CERTIFICATE OF APPROPRIATENESS

Property: 1405 Arlington Street, Lot 12, Block 159, Houston Heights Subdivision. The property includes a new 3,227 square foot, two-story single family residence and a detached one-story garage situated on a 6,600 square foot (50' x 100') corner lot.

Proposal: New Construction – The applicant was approved for a new two-story single-family residence at the March 2013 HAHC meeting. In March the approved residence measured 36'-5" wide, 68'-9" deep, built on a 2' slab foundation with an eave height of 23'-7" and a ridge height of 33'-7".

EAST ELEVATION – FRONT FACING ARLINGTON STREET

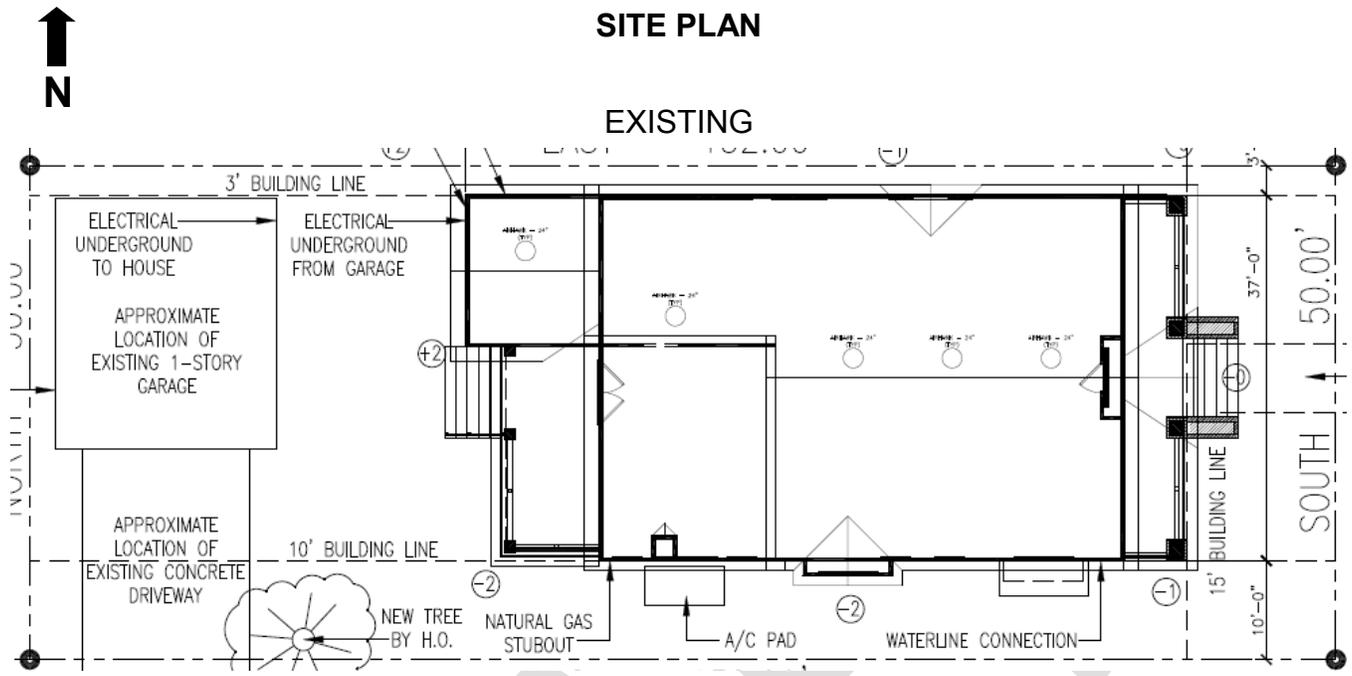
- Replace the 17 existing 4-over-1, 6-over-1 and 9-over vinyl sash windows on the east and south elevations with vinyl 1-over-1 sash windows.
- The proposed windows will be recessed to give the appearance of a traditionally mounted south window.

Design Tech will replace the existing sashes on the east and south elevations of the house with vinyl sashes that more resemble traditional windows.
